NELSON CITY COUNCIL

Proposed Plan Change 13 – Marsden Valley Re-zoning and Structure Plan Project

Planning Officers Report - Addressing Submissions on the Plan Change prior to Hearing Parts A, B and C

Date of Hearing: 18th and 21st June 2010

Map 1 - Proposed NRMP Overlays

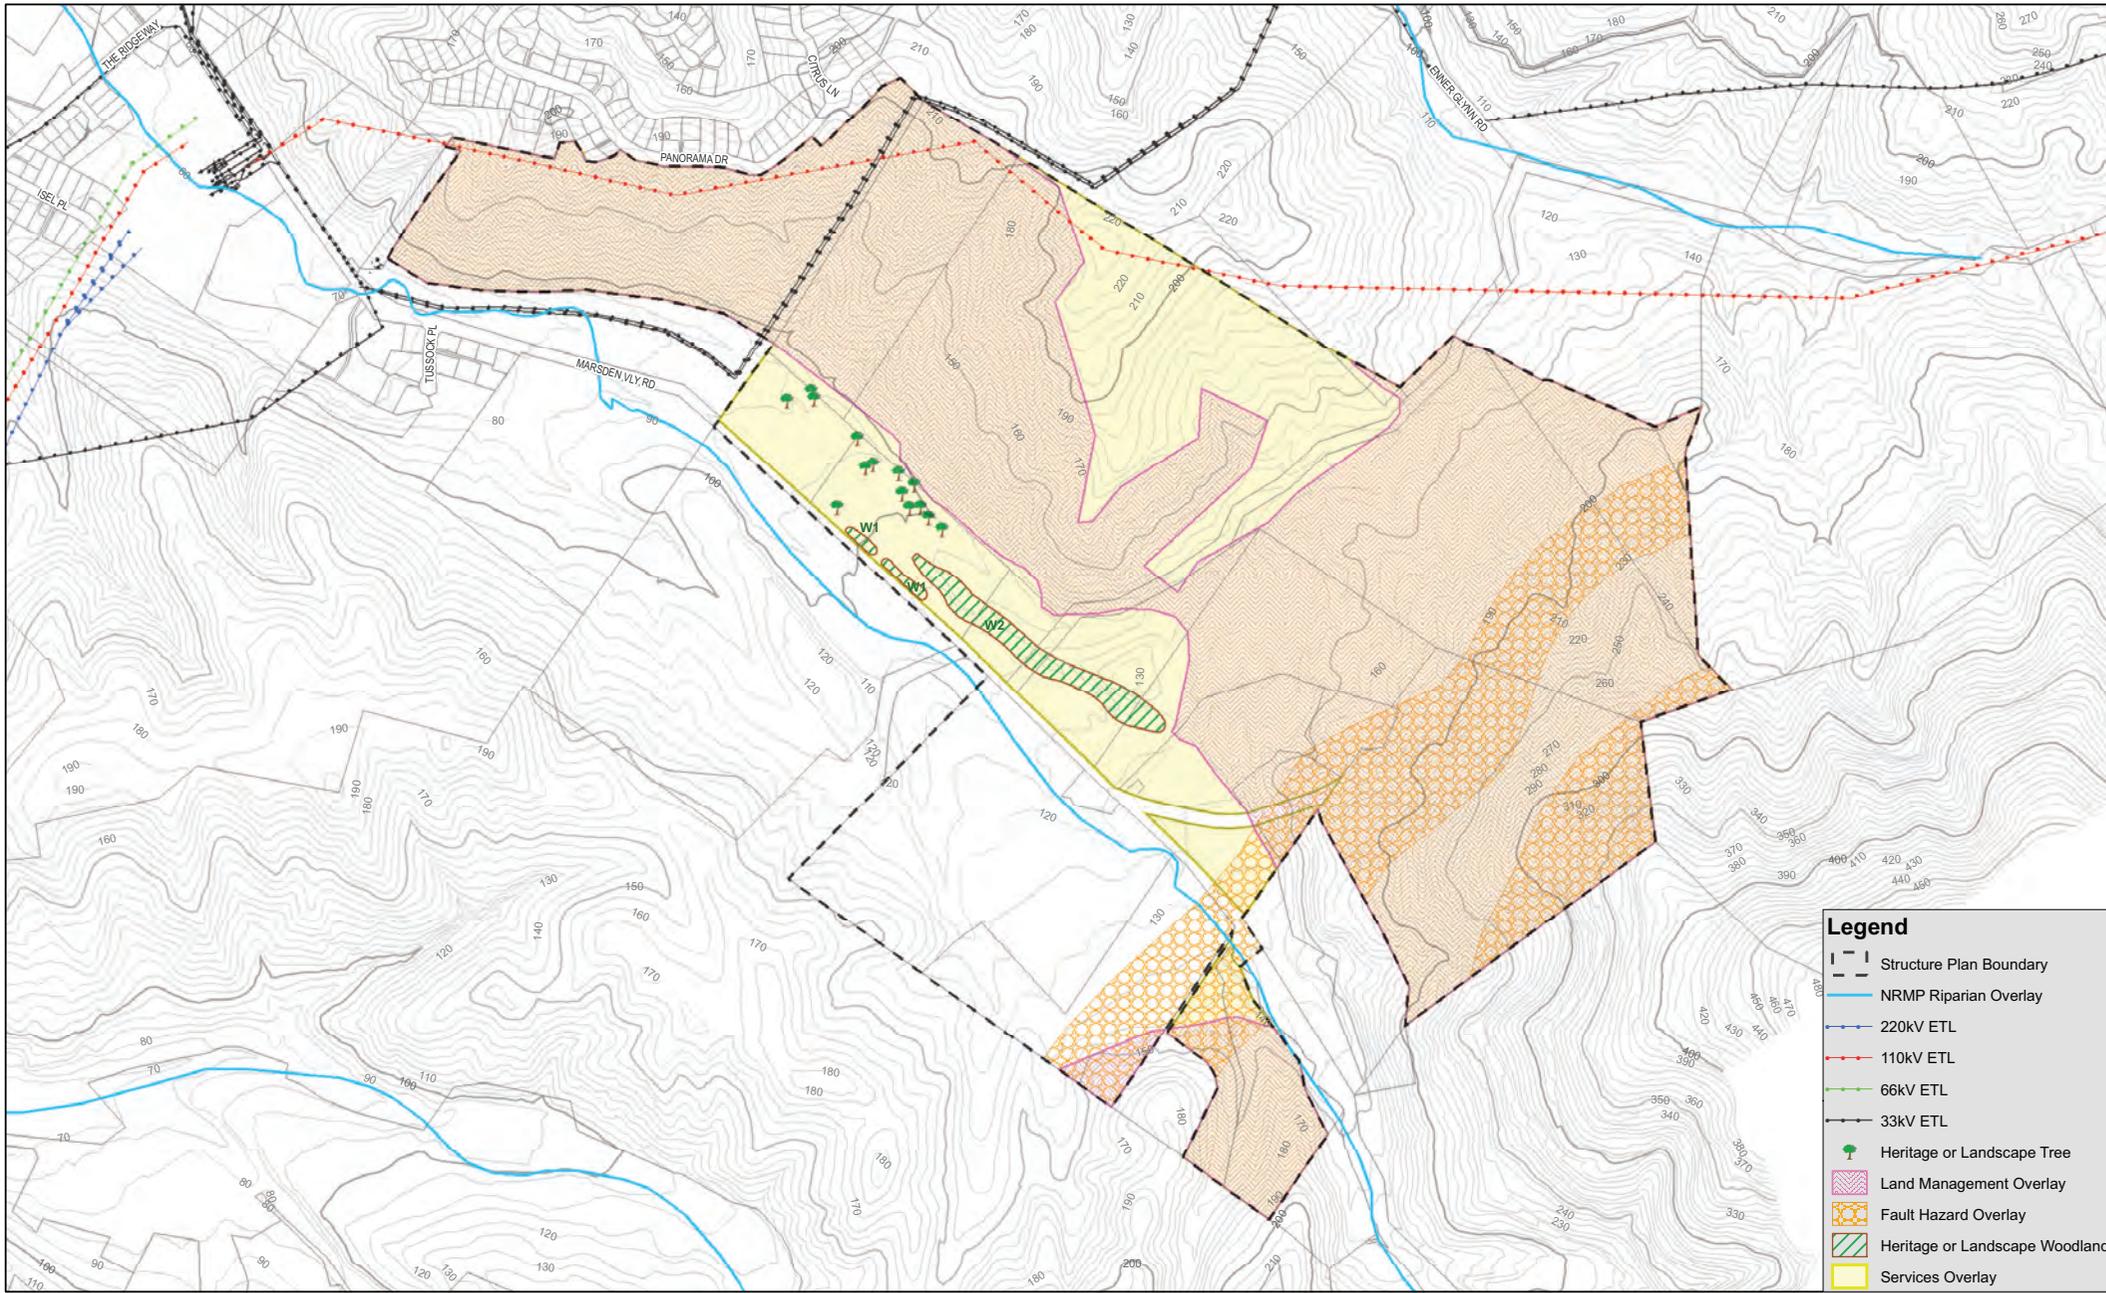
Delete **Figure 1 of Schedule I (Residential Zone)** and replace with the structure plan –map 3 attached

Map 2 - Proposed NRMP Zoning

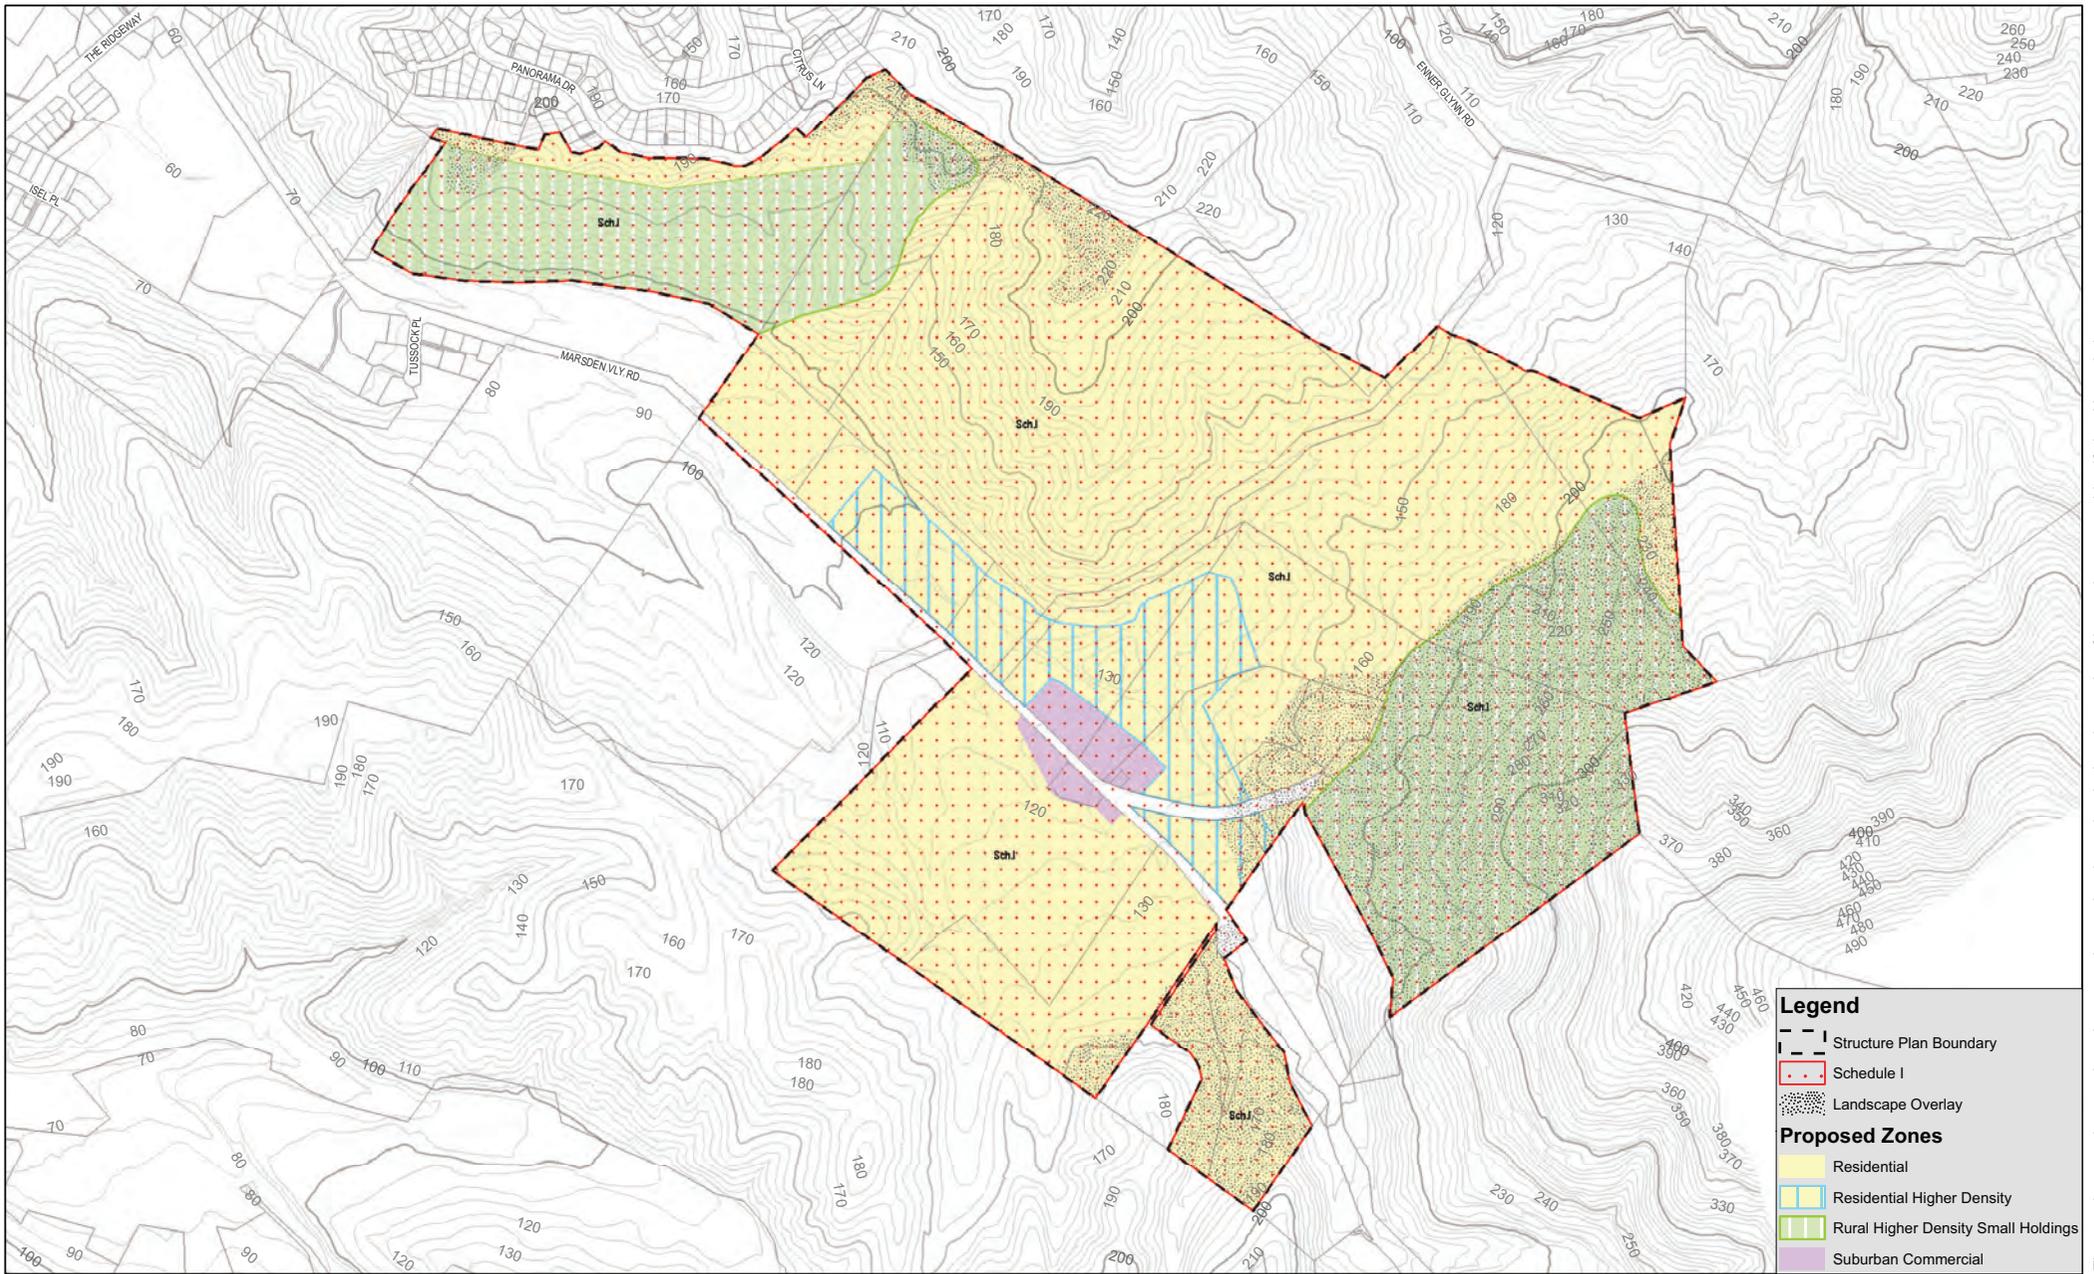
- 3.31. Planning Maps 28, 31, 34, 54 and 55 (left hand side) show the revised overlay information such as the Fault Hazard, Land Management, Services, and Heritage Trees and Woodlands.
- 3.32. Planning Maps 28, 31, 34, 54 and 55 (right hand side) show the revised zoning, Schedule I and the Landscape Overlay.
- 3.33. The revised Schedule I Structure Plan map is inserted into Chapter 7, Residential Zone.
- 3.34. Chapter 12, Rural Zone currently includes a map for Schedule T covering the Rural Zone portion of Marsden Valley as occurs in the plan prior to this
